CONSTRUCTION AND DEMONSTRATION OF A PROTOTYPE MOBILE MICROREACTOR ENVIRONMENTAL IMPACT STATEMENT

Volume 2 Comment Response Document

Final | February 2022

Figure 1. INL Radionuclide Airborne Releases, curies, from 1991 to 2018. Source: Idahoeser.com

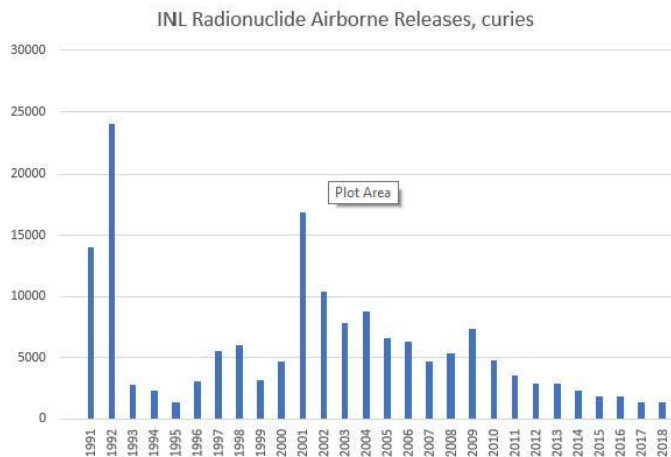
There is a general downward trend in the curie amounts of radionuclides over the last ten years; however, **the releases over the last twenty years have generally been higher than the releases during the 1990s**, see Figure 1. The DOE isn’t about to discuss the increasing radionuclide releases that commenced in 2001.

Figure 2. Department of Energy estimated annual effective whole-body dose in millirem from INL airborne releases. Source: Idahoeser.com

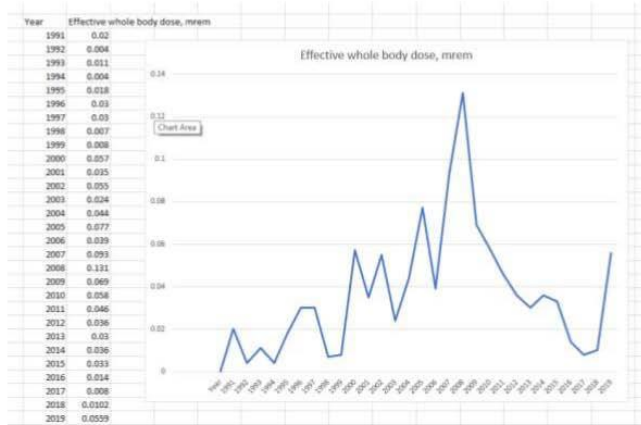
The next thing to know is that for some radionuclides like krypton-85, very large curie amounts yield small radiation doses, while for other radionuclides like iodine-129, plutonium-239 and americium-241, very small curie amount releases yield large contributions to radiation dose. The trend in annual estimated effective dose is provided in Figure 2.

As you can see in Figure 2, the radiation doses from the Idaho National Laboratory from 2000 to 2019 are generally higher than for the 1990s. **And the radiation dose trend over the last few years is increasing, not decreasing.** This is without accounting for ingestion of radioactive animal tissue, which the draft EIS does discuss, but I have not included here. The draft EIS asserts that water we drink here, which sporadically includes high levels of radionuclides such as tritium and other man-made radionuclides, don't come from the INL and so they don't add these to the radiation dose. The dose from radioactively contaminated food and water not included in the DOE's dose estimates actually dwarf the annual radiation dose estimates.

Figure 3. Ratio of the revised Federal Guidance Report (FGR) 13 thyroid dose conversion factors (DCF) to the original Department of Energy (HUDUFACT.dat) thyroid DCF for radionuclides having the largest increases. (PNNL-22827)

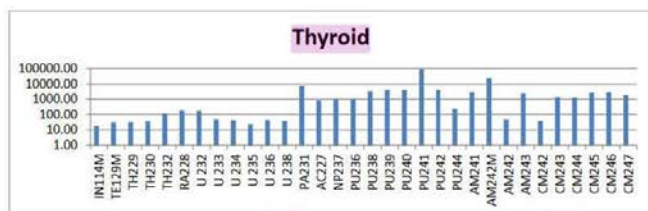
calculating radiation dose but not the risk of higher radiation risks recognized in the EPA's 1999 Federal Guidance Report 13. Buried near the end of the PNNL report is a chart of how wildly increased the thyroid cancer incidence was for various radionuclides, by a factor of 10, of 100, of 1000, of 10,000 and of 100,000! See Figure 3.

The radionuclides in Figure 3 include thorium, uranium and uranium decay progeny, plutonium, curium and americium. The thyroid cancer incidence rate increases for plutonium-238, plutonium-239, plutonium-240, plutonium-241 and americium-241 is over 1000.

Figure 4. Americium-241, plutonium-238 and other actinides released by the INL between 2001 and 2018.

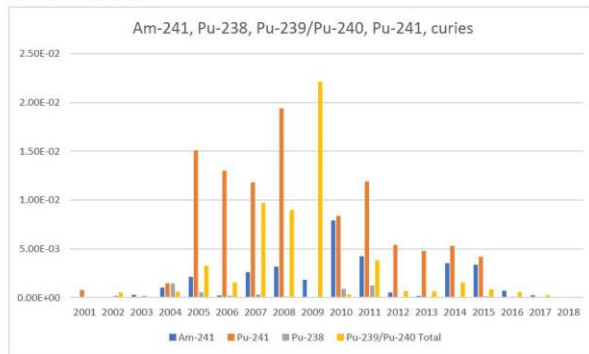
The Draft EIS must include not the deceptive look at five years of estimated effective whole-body doses from INL's airborne waste effluents, it must include the trending of the releases of americium, plutonium and iodine releases from the INL. Figure ?? shows the plutonium and americium-241 releases from the Idaho National Laboratory between 2001 and 2017 based on Department of Energy environmental monitoring reports.⁴¹ The State of Idaho DEQ does not display, report or trend any data before 2013....can anyone guess why? The huge releases from the INL between 2004 and 2013 are shocking and certainly would not fit well with a tourist brochure for visiting Idaho.

Figure 5. Iodine-129 and iodine-131 released from the INL between 1973 and 2018.

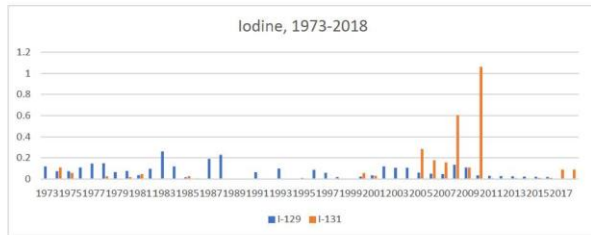
Figure 5 shows the iodine-129 and iodine-131 releases between 1973 and 2017, in curies. The State of Idaho DEQ went from displaying all of their environmental monitoring reports to displaying ten years of the reports, to now displaying only six years of annual reports and only 4 years of quarterly data reports from 2013 to 2018. **Again, here you can see why the Idaho DEQ didn't want to display INL monitoring data before 2013.**

The plutonium and americium-241 and the iodine-129 and iodine-131 are not the only radionuclides with elevated releases from the INL. But these radionuclides might have influenced the elevated thyroid cancers in Bonneville County reported for 2013 to 2017, yet the Department of Energy continued ignoring the thyroid organ doses.
